RE: Secondary Containment Evaluation and Recommendations  
Nevada Environmental Response Trust  
Henderson, Nevada

**Subject:** NERT – GWETS Piping Secondary Containment

## Review of Above Ground Piping Outside Secondary Containment

FIGURE No.2  
EQUALIZATION AREA UNCONTAINED PIPING

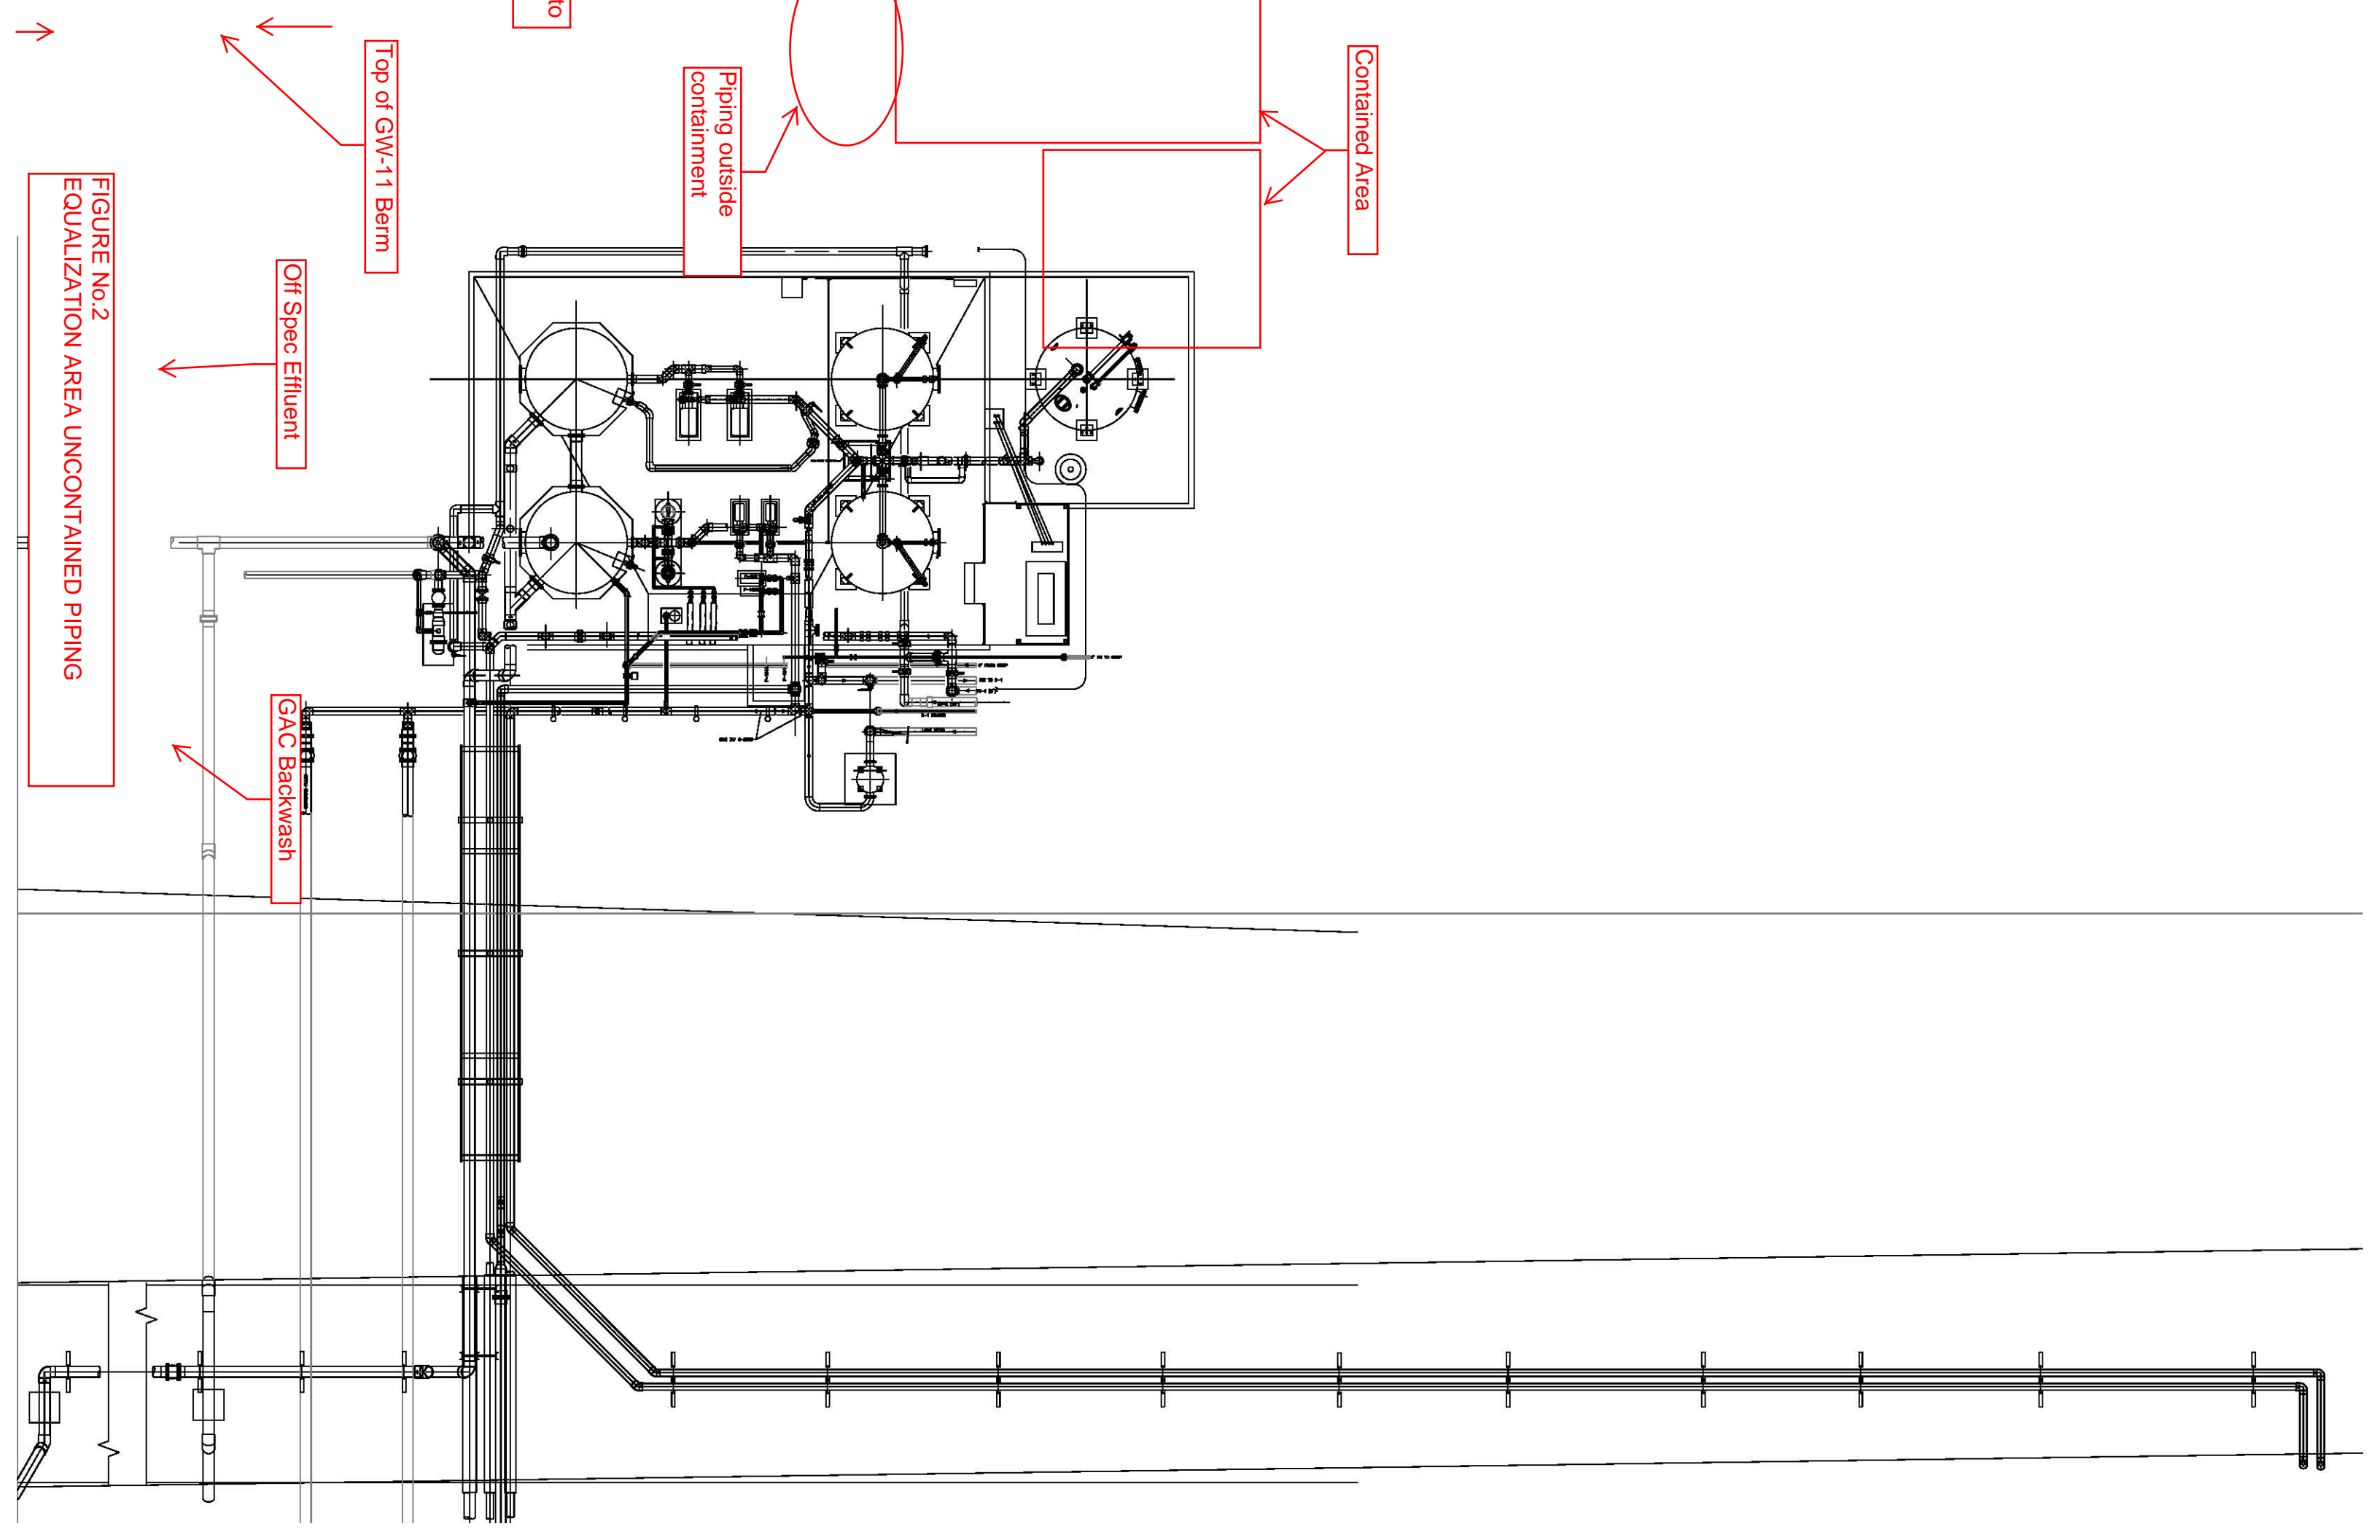
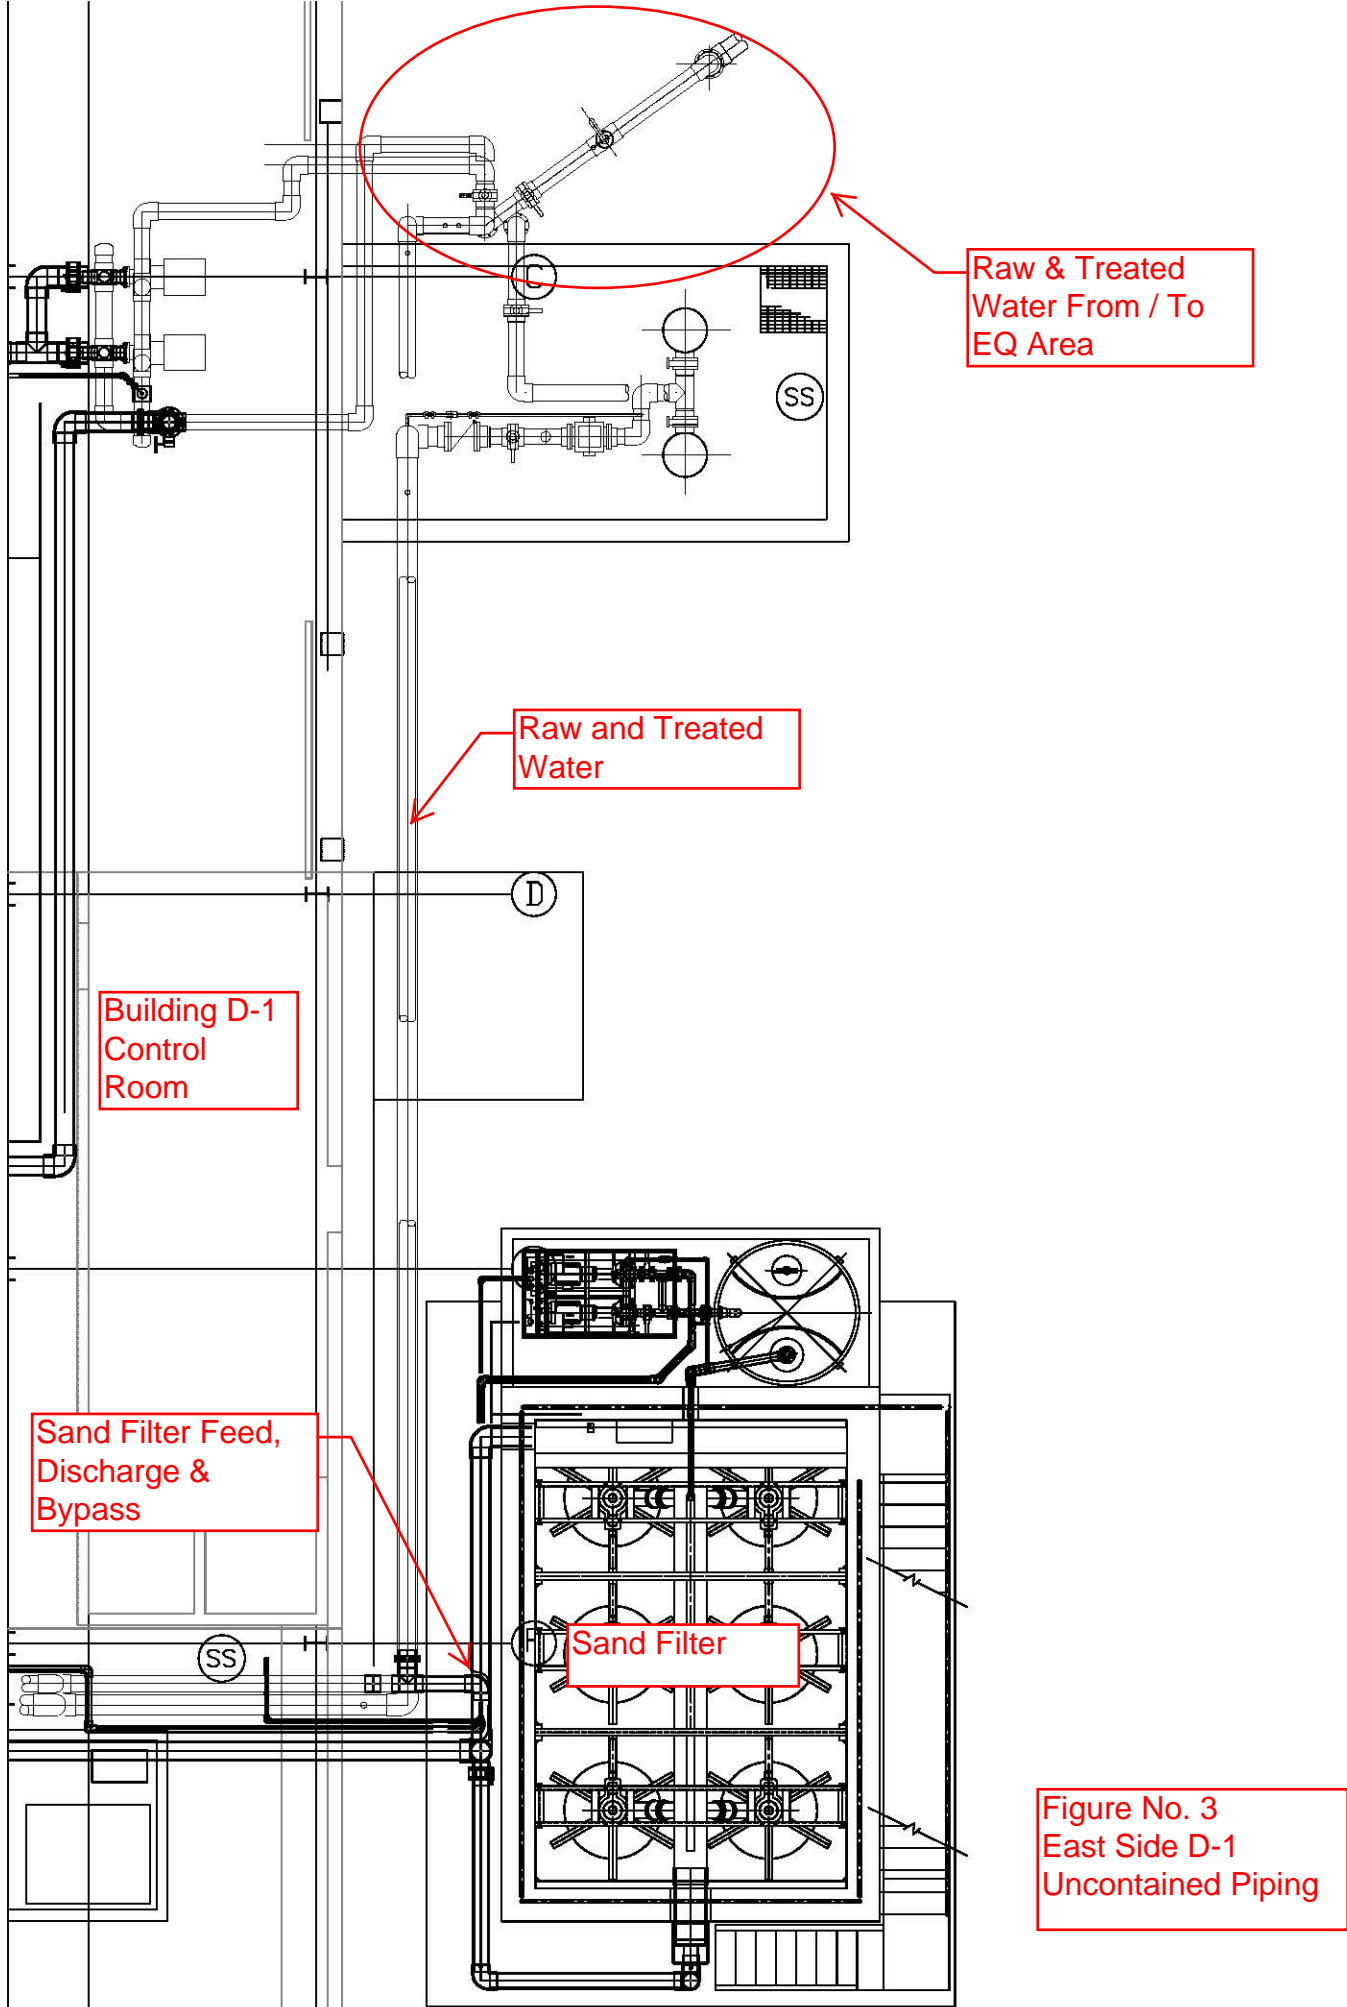
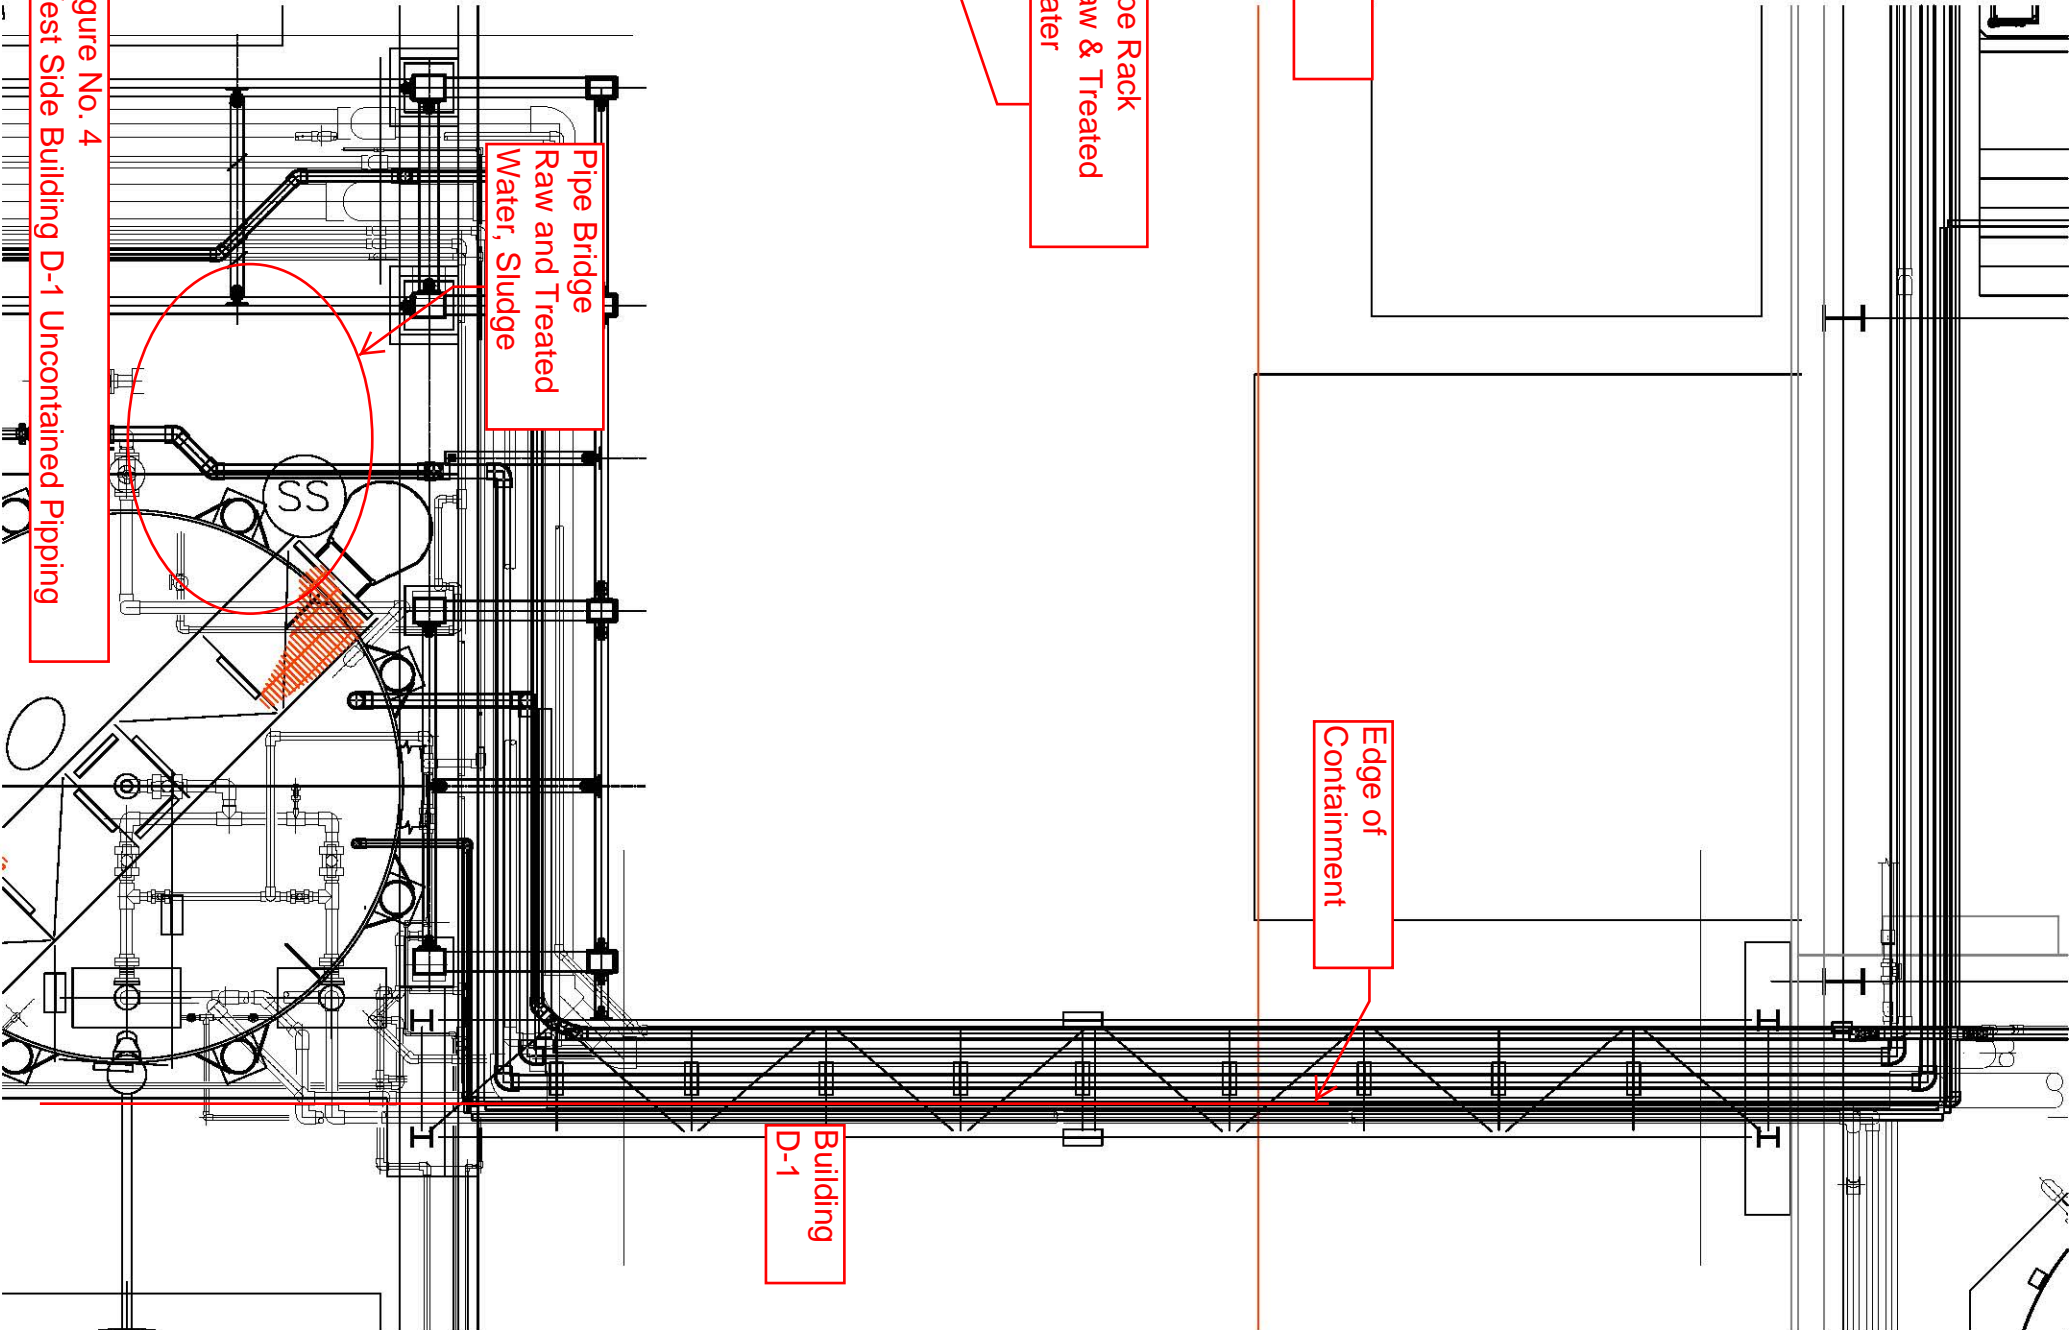
Identifies piping outside the EQ containment pad and on the GW-11 containment berm. The EQ pad is contained and its sump pumps to GW-11.

- The Equalization Area (EQ Area) has two types of raw water pipelines: one 4-inch pipe from the GWTP and several 12-inch pipes from the well fields, from the GW-11, and from the GAC effluent. Tetra Tech recommends extending the containment pad at the EQ Area around the raw water pipe, installing a concrete curb, and coring openings into the existing containment area. If raw water is spilled, then it will flow towards the existing sump in the EQ area. By installing this new containment pad and curb, treated water in the area will also be contained.

- Tetra Tech also recommends installing a HDPE liner underneath the raw water pipe installed on the slope under the bridge to GW-11. With this liner in place, any spilled raw water would flow towards the EQ Area and new containment pad and then to the existing containment area where a sump is already installed.
